Comments to the Ohio Power Siting Board re: Case No. 22-0549-EL-BGN, Oak Run Solar; and 22-0550-EL-BTX: Oak Run Solar Transmission Line, Madison County

Comments to the Ohio Power Siting Board re: Case No. 22-0549-EL-BGN, Oak Run Solar; and 22-0550-EL-BTX: Oak Run Solar Transmission Line, Madison County

Comments to the Ohio Power Siting Board re: Case No. 22-0549-EL-BGN, Oak Run Solar; and 22-0550-EL-BTX: Oak Run Solar Transmission Line
Madison County

Figure 1 Fencing for Big Plain Solar facility as seen from Hume Lever Road, Madison County 10/16/2022

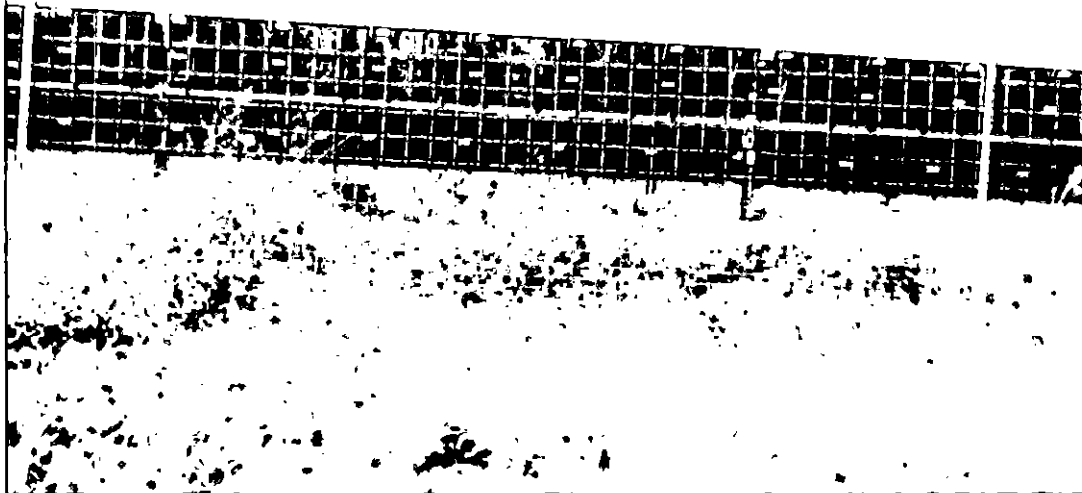
Figure 1 shows an example of a fence we do not believe is wildlife friendly. This photo shows a woven wire fence at the Big Plain Solar facility as seen from Hume Lever Road in Madison County. As can be observed in this photo, the wider weave is not appropriately mounted at the bottom. This is not the mounting that should be used for wildlife-friendly fencing, as it is too small on the bottom for mammalian predators to readily pass through. Also, please see the discussion below for the size of the weave that is necessary for predator passage. The wider weave on this Big Plain fence might not be large enough for mammal predator passage. We are concerned that “deer fencing” might not be appropriate and wildlife-permeable (or wildlife-friendly). For example, as mentioned above in contrast to the discussion on North Carolina fence, this weave does not appear to be at least 7x8” or 7X9” and might not allow passage by predators of small mammals, such as foxes and coyotes.

Where the fence weave varies in size from top to bottom of the fence, a “wildlife friendly” fence is usually mounted with the larger (i.e., 7x8” or 7X9”) opening on the bottom. If a small weave is on the bottom near the ground, that is not passable to wildlife – see Figure 1 above - it would not be “wildlife friendly.” Again, see the above fence installed in 2022 at Big Plain Solar along Hume Lever Road in Madison County.

- Any facility fencing should be “wildlife-permeable” or “wildlife-friendly. This includes predators such as foxes and coyotes.
- We encourage a “wildlife-friendly” fence that has a continuous, wider (7x8” or 7X9”) weave, with continuous openings in the weave that are large enough and in the right position (at and near the

ground) to allow for mammalian predator passage through the fence (e.g., large enough for red foxes and coyotes to pass through, at least). The fence also should allow the passage of turtles (such as Eastern box turtle (*Terrapene carolina carolina*), and where there is suitable habitat (streams, wetlands), Midland painted turtle (*Chrysemys picta marginata*) and Snapping turtle (*Chelydra serpentina*)).

- Chain link fence should be avoided.
